RE: proposed alterations and additions to an existing dwelling.

Application No. **DA 2023/0647**

Address: **13 Alleyne avenue NORTH NARRABEEN**

**RE: DA2023/0647 PROPOSED ALTERATIONS AND ADDITIONS TO AN
EXISTING DWELLING AT
13 ALLEYNE AVENUE, NORTH NARRABEEN, NSW 2101 LOT 46 DP 7593**

Please refer to the Proposed Built Form Visual Impacts Dwg. No. 1

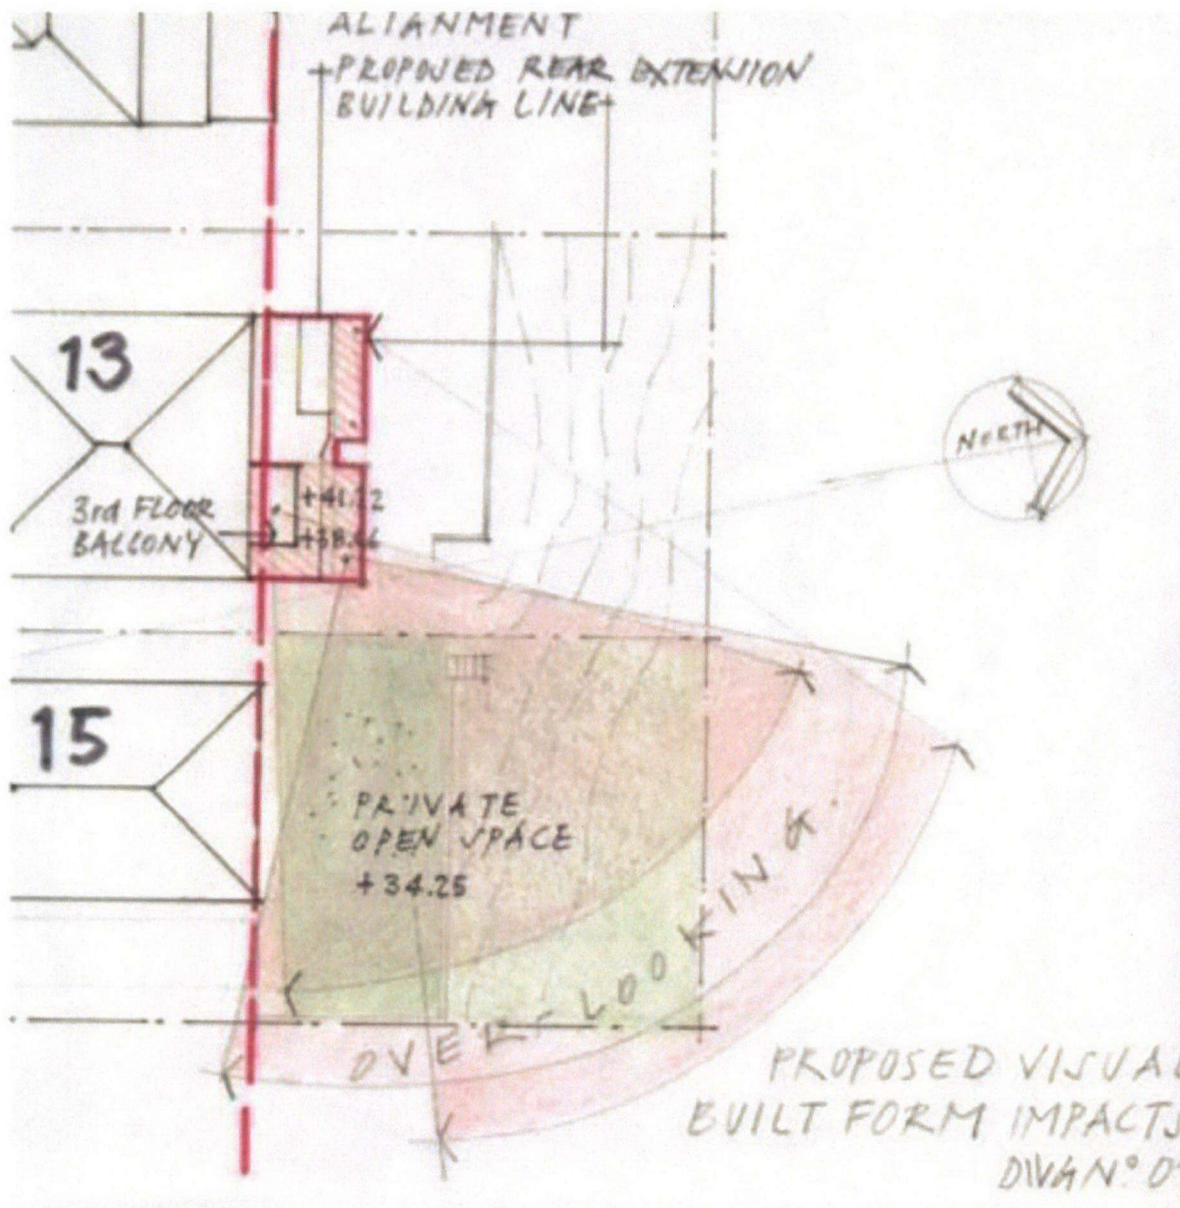
But the effects of the height and extra bulk and scale of no.13 (designed as an almost sheer 3 storey 'wall' of built form) obviously does not take into account the slope of the land by 'breaking' up the bulk to 'step down the slope'.

Whereas the neighbour's home at No.15 is far more appropriately designed and sited as it 'steps down the slope' (while also creating a more 'earth sheltered' and energy efficient home). but by doing this it is adversely impacted by the adjoining proposal that does not account for natural slope of the land.

While the proposed new roof and the proposed verandah extension will also protrude way past the existing built form alignment pattern established by the neighbouring properties.

Additionally, there are detrimental impacts to the visual privacy and overlooking caused to the neighbouring property at No.15 caused by the extent of the rear deck's height, bulk and scale.

DIV N° 02

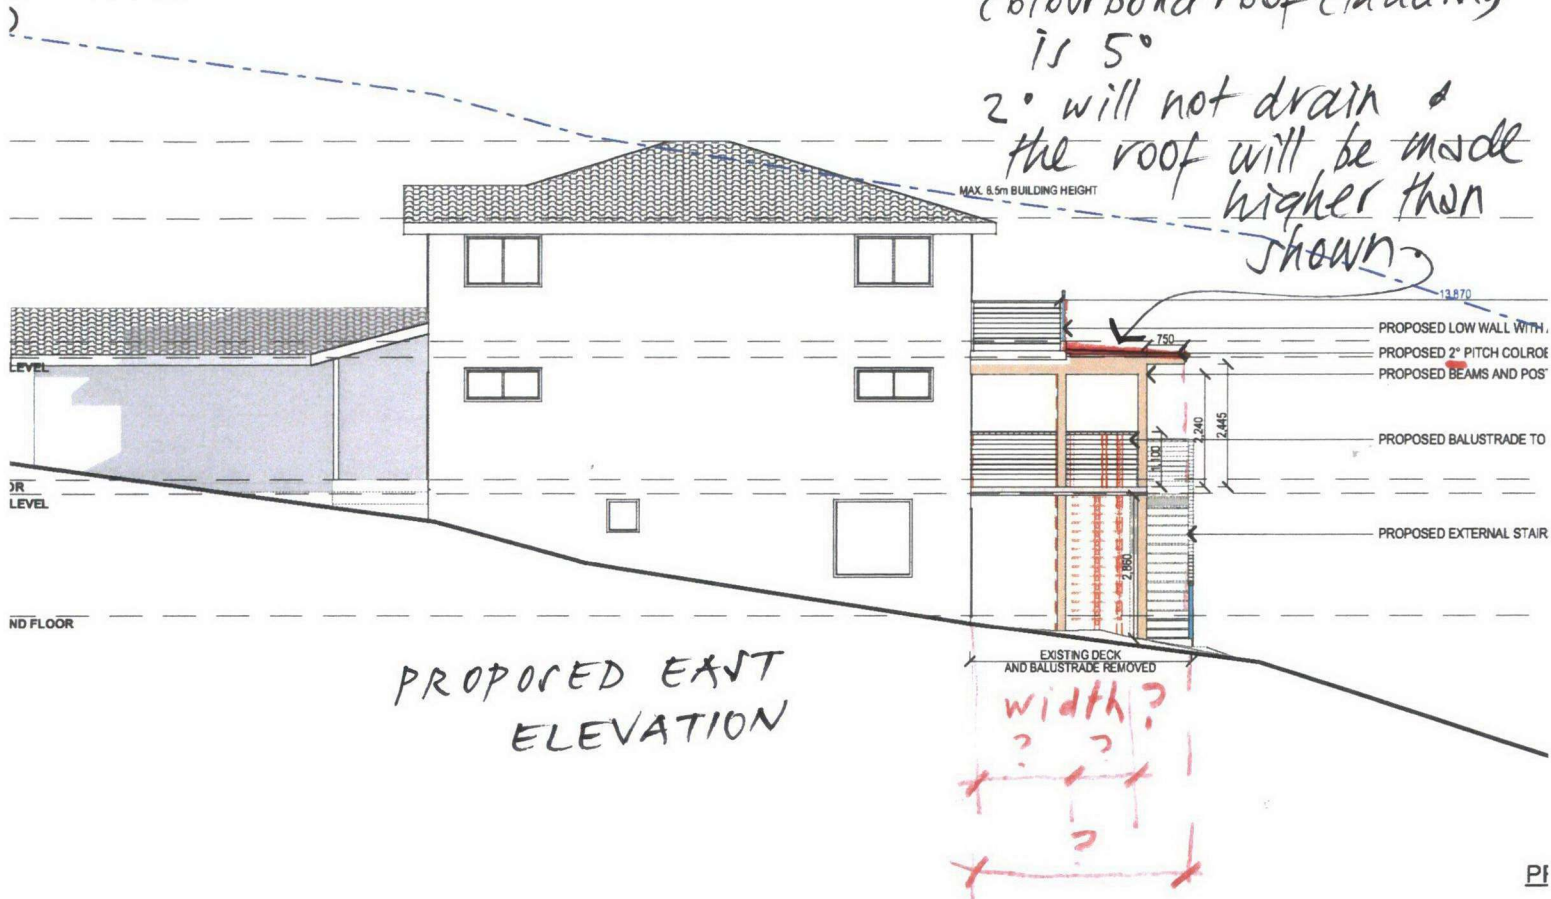
As well as a copy of the Proposed East Elevation denoting issues where critical depth/width dimensions are not shown in the proposal. Dwg.No.02

TO COMPLY WITH AS 2801 &
CODE OF PRACTICE.

please note:

minimum roof slope for
colourbond roof cladding
is 5°

2° will not drain &
the roof will be made
higher than
shown

DIMENSIONS ~
NOT SHOWN
